LA SALLE TEMPORARY GUARDRAIL
PROJECT NUMBER 20107

LaSalle Hotel Condition Assessment

Re: Engineering Services
Window and Rooftop Water Tank Structural Evaluation
LaSalle Hotel
120 S Main St, Bryan, Texas 77803

GUARDRAIL DETAILS

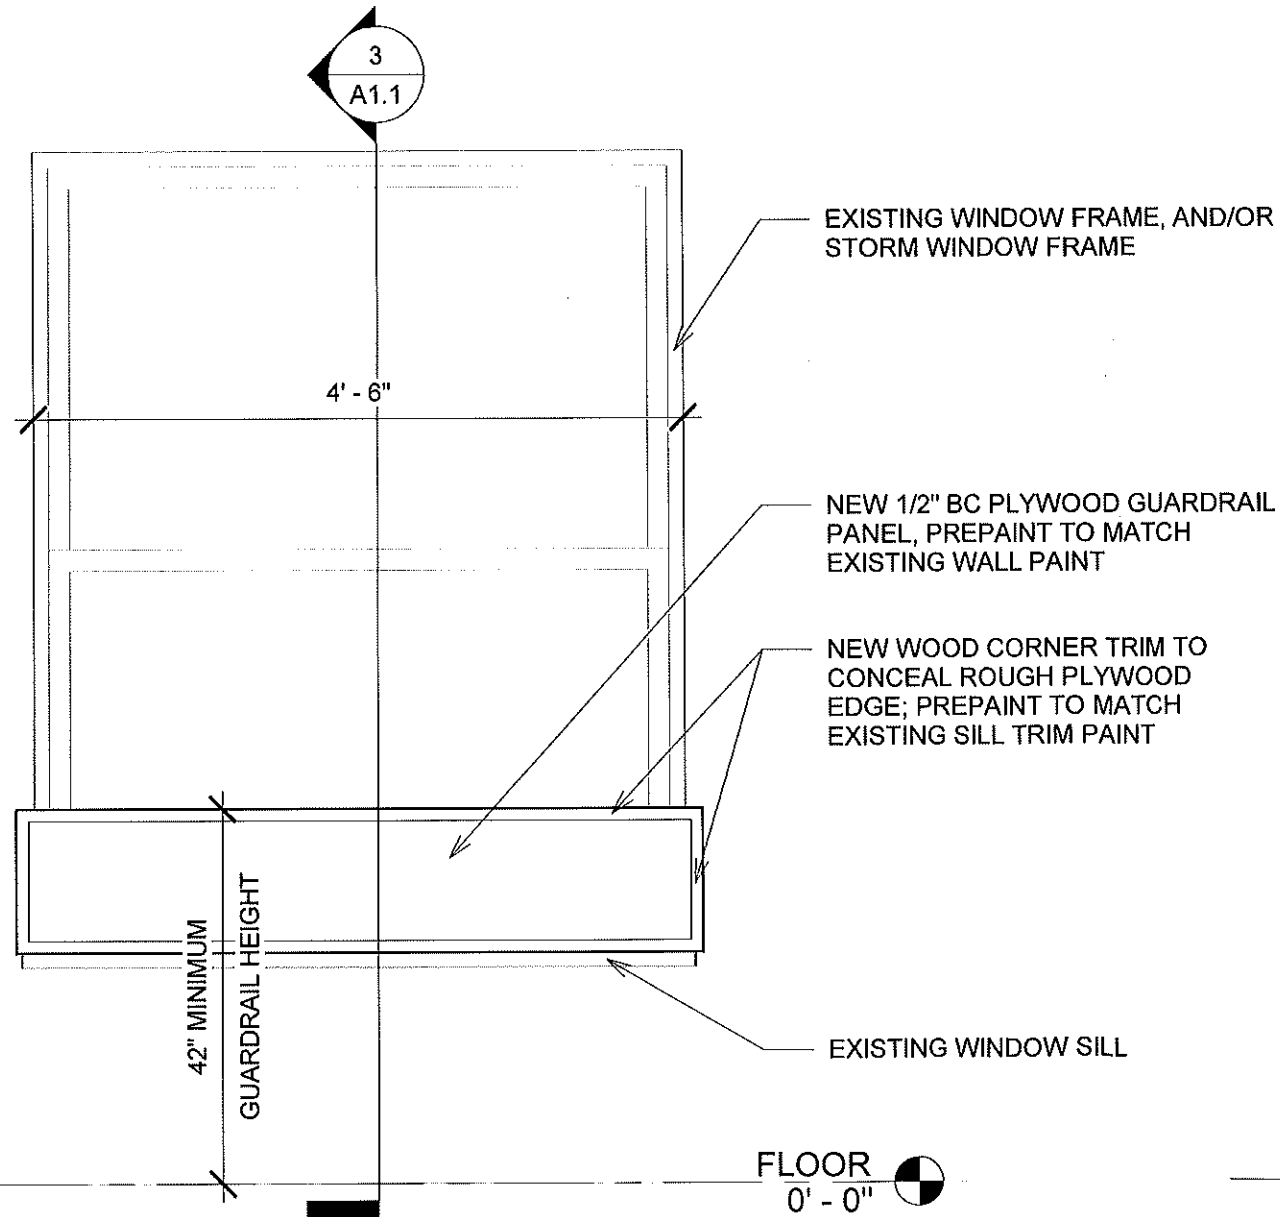
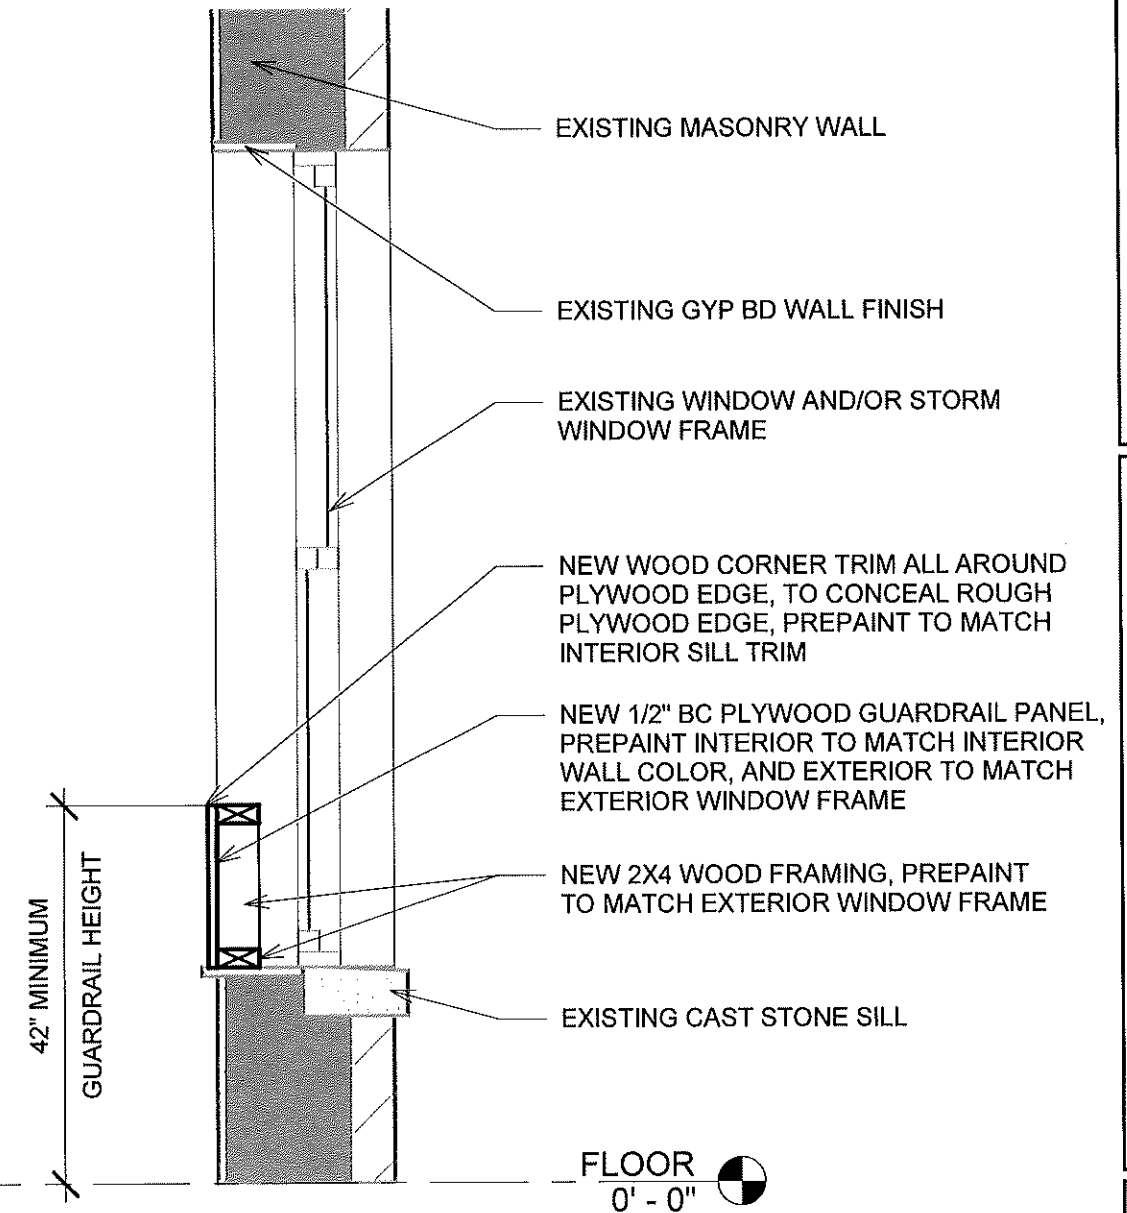
PROVIDE ONE COMPLETED AND PAINTED SAMPLE MOCKUP GUARDRAIL FOR ARCHITECT APPROVAL, PRIOR TO COMPLETING REMAINING WINDOW GAURDRAILS.

ARCHITECT TO INSPECT EVERY WINDOW, & SELECT SPECIFIC WINDOWS TO BE PROTECTED BY GUARDRAILS

Figure 2405.3
Maximum Allowable Area For Vertical
And Sloped Glass
Based on Width-to-Length Ratios of 1:1 to 1:5

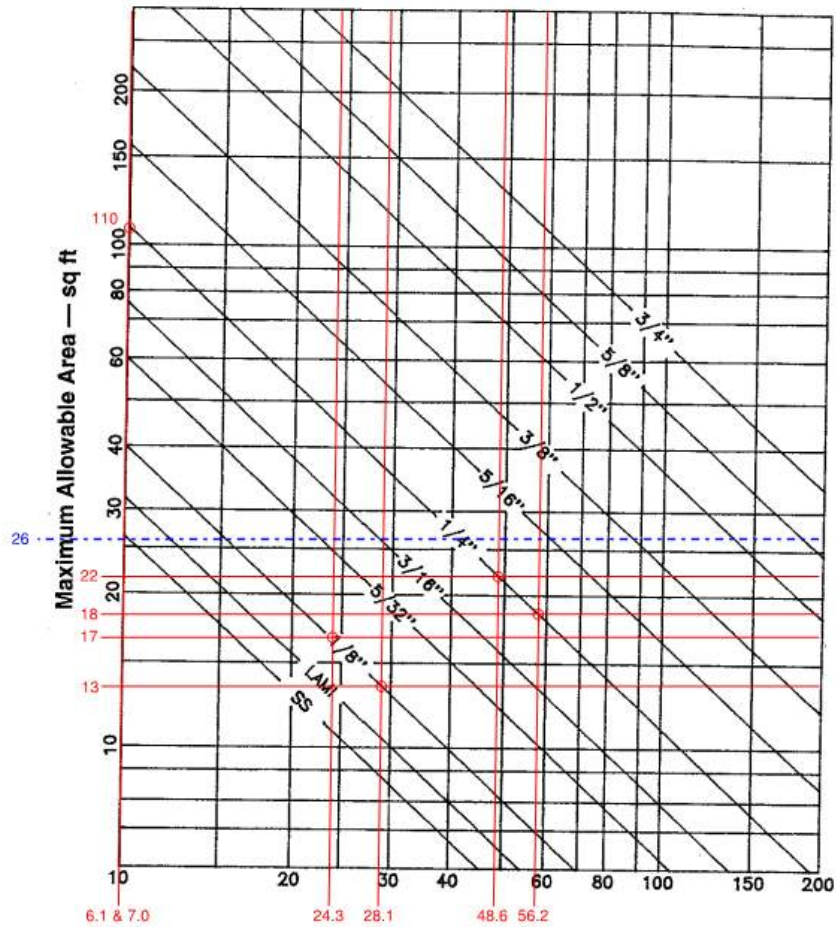
adequate based upon 1994 SBC Figure 2405.3, which has inputs “factored load” and “glass thickness” to output the allowable area of a single pane of glass. The factored load is determined by dividing the design wind pressure by factors provided in 1994 SBC Table 2405.3A (shown below).

Shown on the next page is 1994 SBC Figure 2405.3 with red lines depicting values “factored load values” and “allowable window areas” calculated for this property. The dashed blue line depicts the square footage of a 54” x 70” window for reference, which is the size of most windows on the project. It should be noted that this design methodology is meant for the design of a single pane of glass, and that stiff interior supports, such as sashing can be used to break up a window's span. As was previously discussed, the wooden-sashed windows have been determined to be structurally inadequate due to extensive wood rot, thus only the storm windows remain at those

locations (which are made of a single 1/8" thick glass panel). The steel-framed windows on the other hand are broken into 4 panes of glass. As previously discussed, exterior rust

All calculations have been compiled into a table in Appendix B showing all the relevant numbers used in determining the adequacy of the exterior facing windows. In general, all store-front and steel framed windows have been determined to be adequate and all wood framed windows have been determined to be not safe.

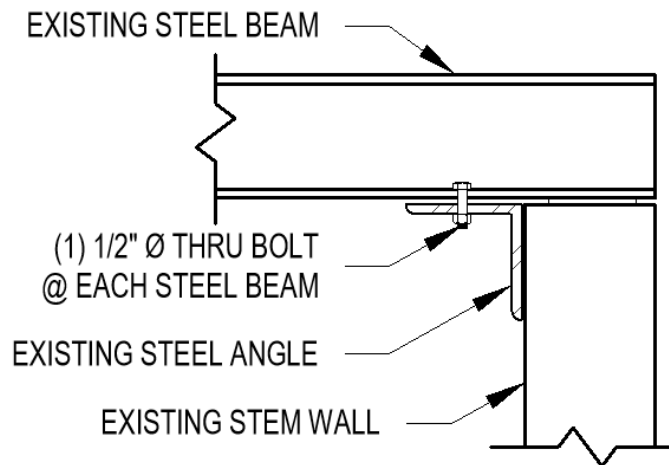
The water tank structure at the top of the building is an inactive water tank (always empty) that sits on flatwise 2x12 deck spanning between S6x12.5 steel beams spaced at 17" on center. One end of these beams bears into a masonry wall and the other sits on a concrete stem wall with a L6x6x3/8 ledger. The 2x12 deck shows signs of water damage, and the S6x12.5 beams are showing signs of rust in the top flange. From the perspective of the weight of the tank and supports, DDE is not concerned. This system was originally designed for the scenario in which the water tank is full of water. The observed deterioration is not pervasive enough to suggest that the supporting structure is inadequate. Laterally however, DDE is concerned about the lack of a reliable load path between the steel beams and the stem wall. DDE recommends either that the tank be removed, or that the bottom flange of the steel beams be connected to the steel ledger angle with thru bolts for the purpose of transferring wind forces down into the building. Reference the detail provided below.

NORTH - 3H

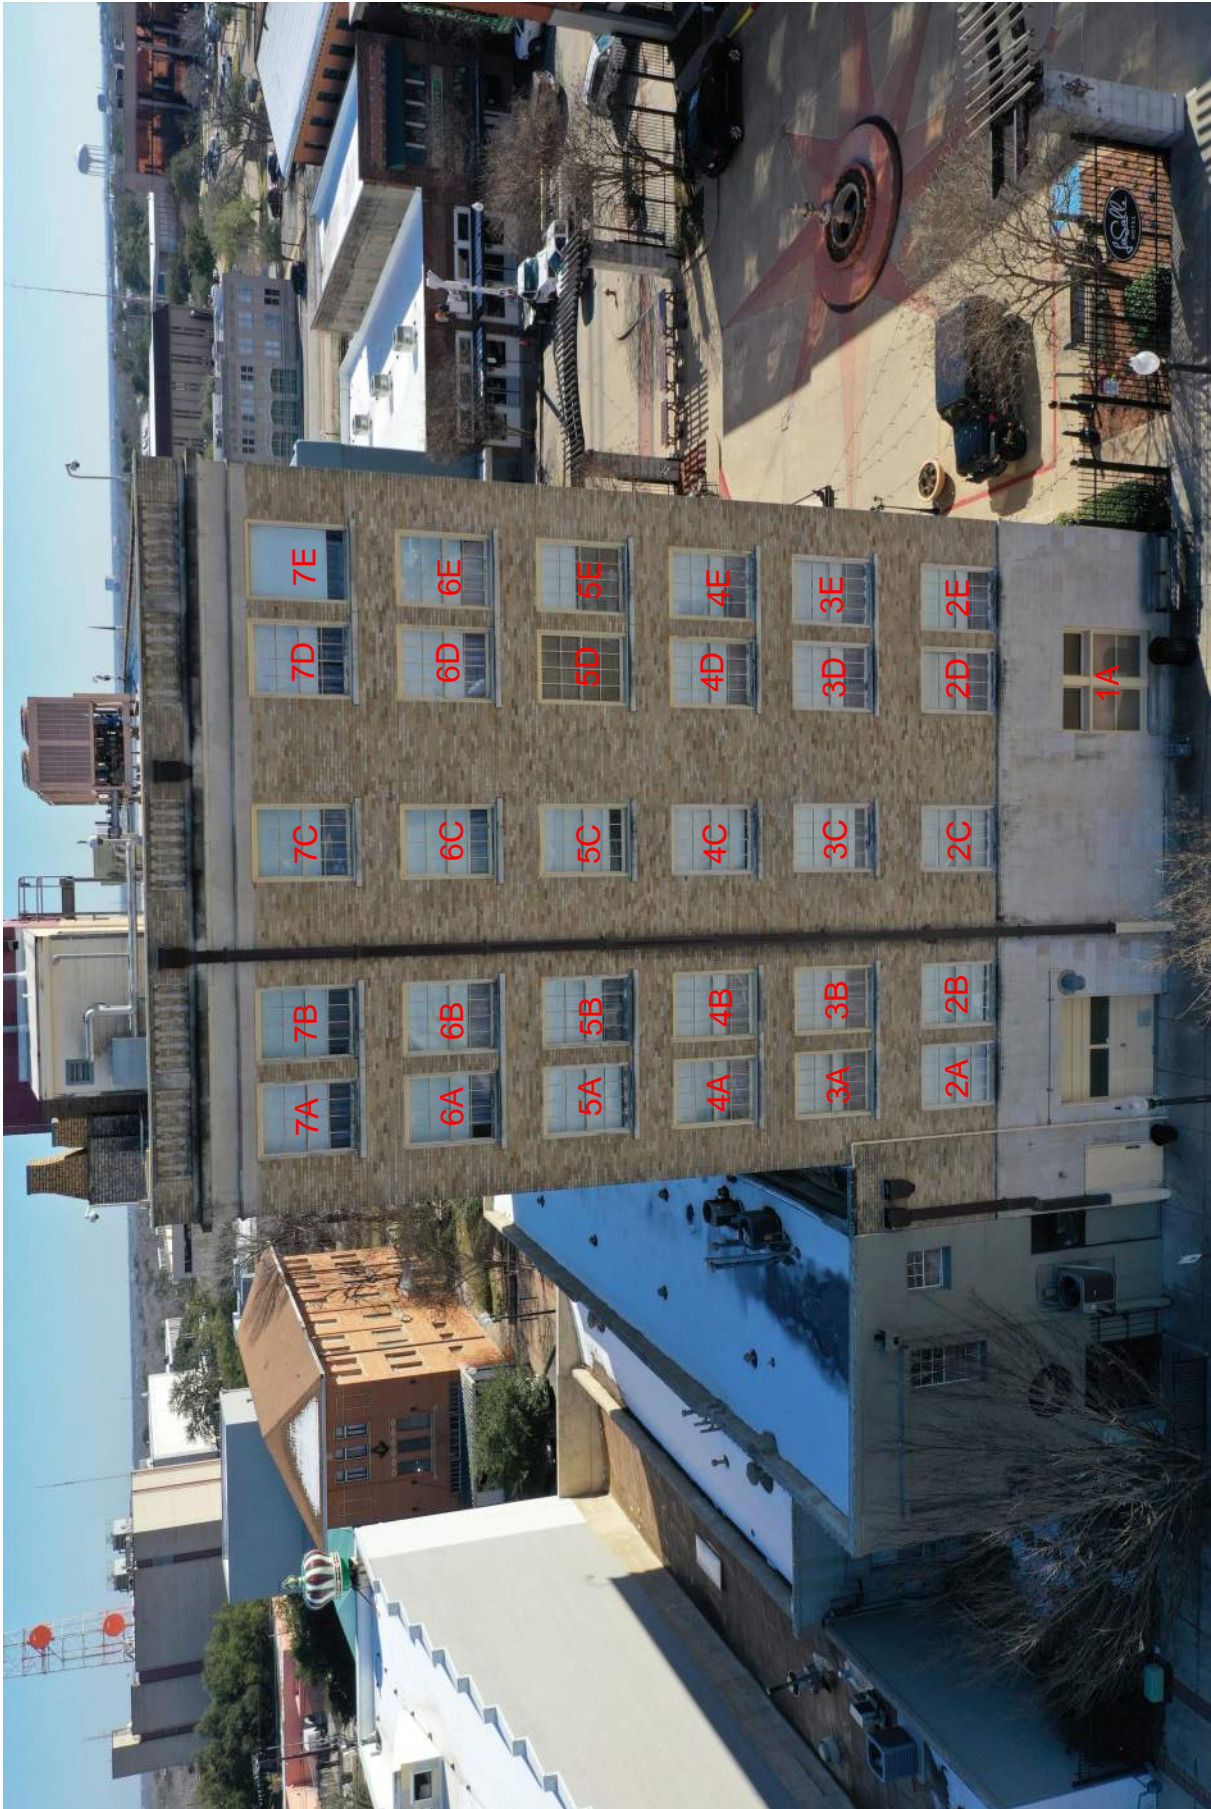
Notes: Storm window.
